August 17, 2017
GO2-17-147

Subject: **COLUMBIA GENERATING STATION, DOCKET NO. 50-397
ENERGY NORTHWEST'S NOTIFICATION OF FULL COMPLIANCE WITH
ORDER EA-12-049, "ORDER MODIFYING LICENSES WITH REGARD TO
REQUIREMENTS FOR MITIGATION STRATEGIES FOR BEYOND DESIGN
BASIS EXTERNAL EVENTS"**

**FINAL INTEGRATED PLAN FOR THE MITIGATION OF BEYOND-
DESIGN-BASIS EXTERNAL EVENTS**

Figure 1: Phase 2 Water Makeup Flow Diagram

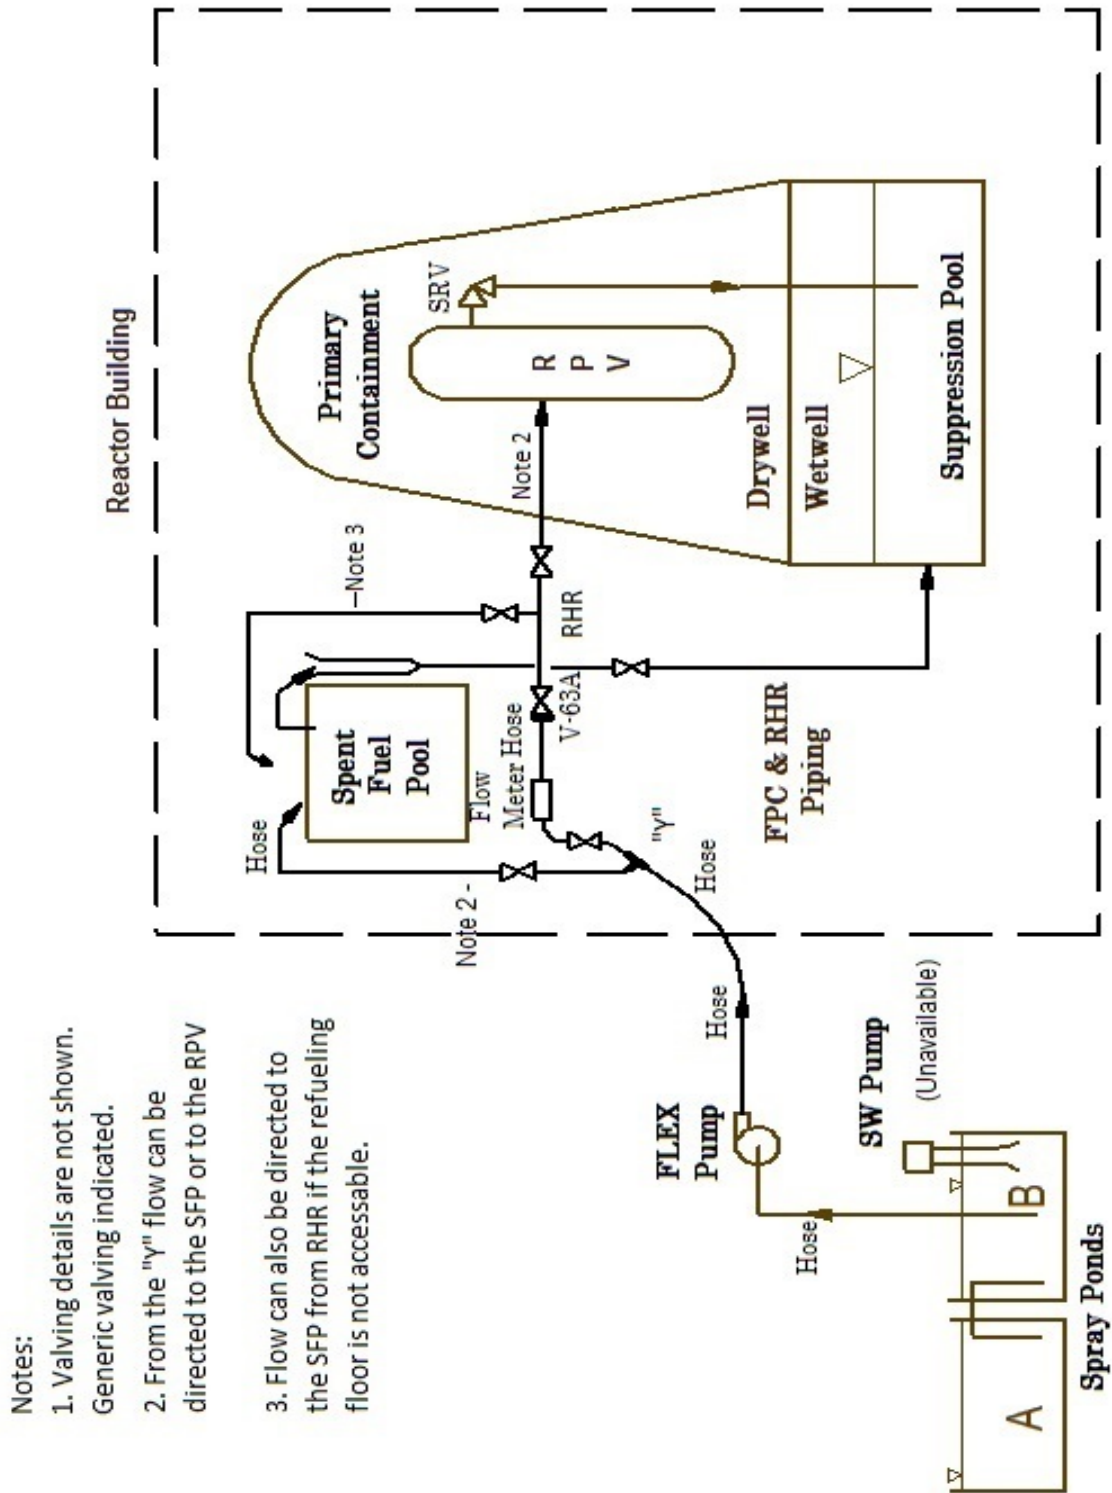
Audit Question 41: The NRC staff asked the licensee to provide further detail of the paths and the locations of the connections points as well as the validation of the ability to perform the actions.

Water is supplied to the RHR system by installing a flanged connection hose fitting to the blind flange of 3" gate valve RHR-V-63A, RHR-V-63B, or RHR-V-63C. If the reactor building 606' elevation is accessible, the preferred connection point is RHR-V-63A based on valve location and ease of installation. If inaccessibility of RB 606' floor is anticipated, then RHR-B must be used. RHR-B loop is the only loop that has an existing cross tie with FPC to provide a supplemental flow path to the SFP for makeup and cascading flow. Reactor building lighting is not credited in these areas; operators carry flashlights during an ELAP event. The location, accessibility, and complexity for installing a RHR flange connector at each valve location is discussed below. ABN-FSG-002, *Water Makeup Strategies for RPV, SFP, DW, WW, CSTS during an Extended Loss of AC Power or other Beyond Design Basis Event*, details precautions, equipment needed, how the fire hoses are laid out and provides maps associated with the Columbia makeup water strategies.

Figure 2: FLEX Deployment Routes

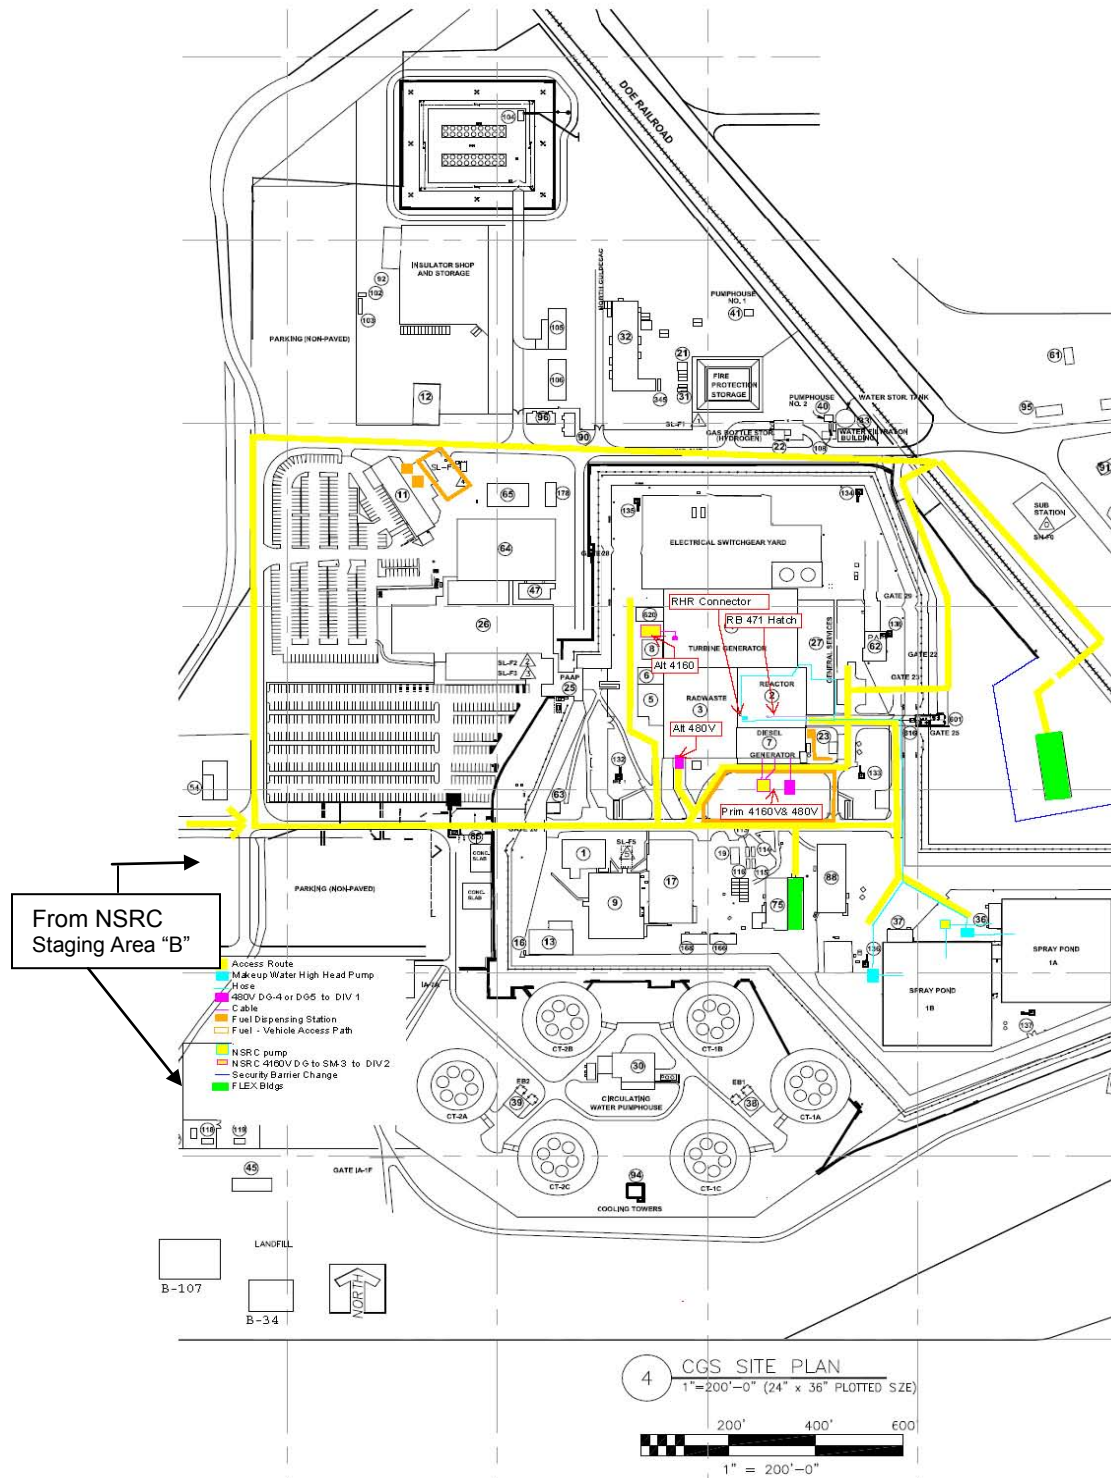
10-E	<p>Evaluation of FLEX equipment to be completed to ensure proper functioning under the design-basis temperatures and ash fall conditions during both operation and storage. This includes manual actions to transport and set up the equipment as well as storage conditions.</p>	<p>Licensee to complete evaluation of operating FLEX equipment under ash fall conditions.</p> <p>Energy Northwest Response</p> <p>See attached discussion.</p>

FLEX Buildings 82 and 600, has been documented to meet the requirements of ASCE 7-10 and are designed to be structurally capable of withstanding wind loading and ash fall deposit. As Columbia occasionally has snow, plans already are in place to remove ice and snow and can be used to any excessive accumulation of ash from the FLEX equipment deployment routes shown in Figure 2 of the Final Integrated Plan.
